# **COSUMNES POWER PLANT (01-AFC-19)**

## **DATA RESPONSE, SET 1A**

Submitted by  
**SACRAMENTO MUNICIPAL  
UTILITY DISTRICT (SMUD)**

JANUARY 9, 2002

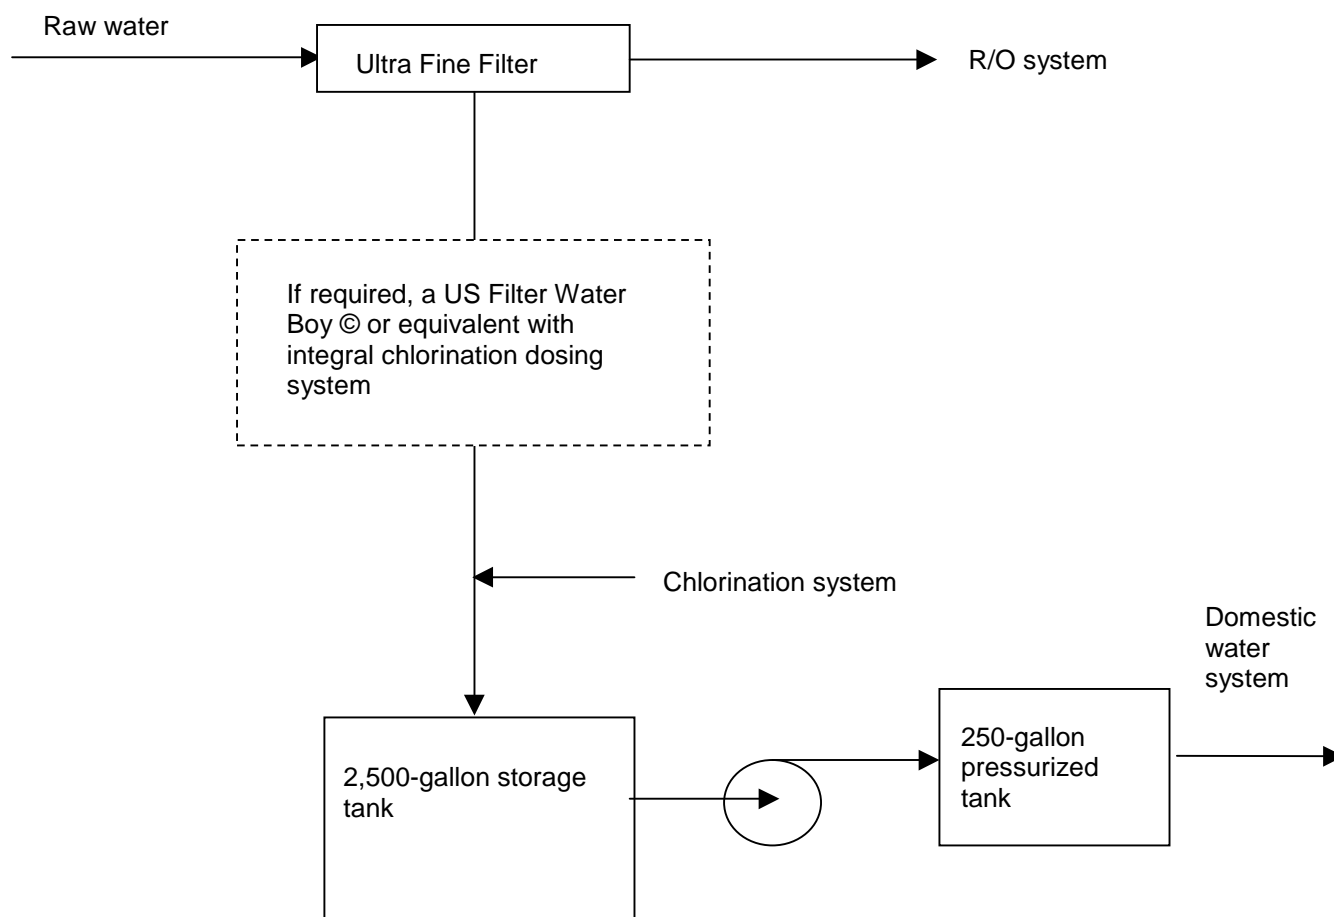
## BACKGROUND

Section 7.2 indicates that potable water will pass through an ultra-filter before being stored in a 2,500-gallon bulk tank and then used to replenish a chlorinated 250 gallon pressure tank. A US Filter Water Boy® package plant is said to employ microfiltration and UV disinfection, but it is unclear how this package plant will interface with the ultrafiltration and chlorination system.

156. Please provide a process flow diagram and description of how the Water Boy® package plant will interface with the UF and chlorination system. In the event of a power outage or potable water equipment failure please explain how sufficient pressurized water will be available to meet all plant safety showers and eyewash requirements in a worst-case scenario such as a chemical spill. Please verify that there will be sufficient chlorine contact time in light of the fact that a pressurized water tank's active volume is usually about half of its nominal volume.
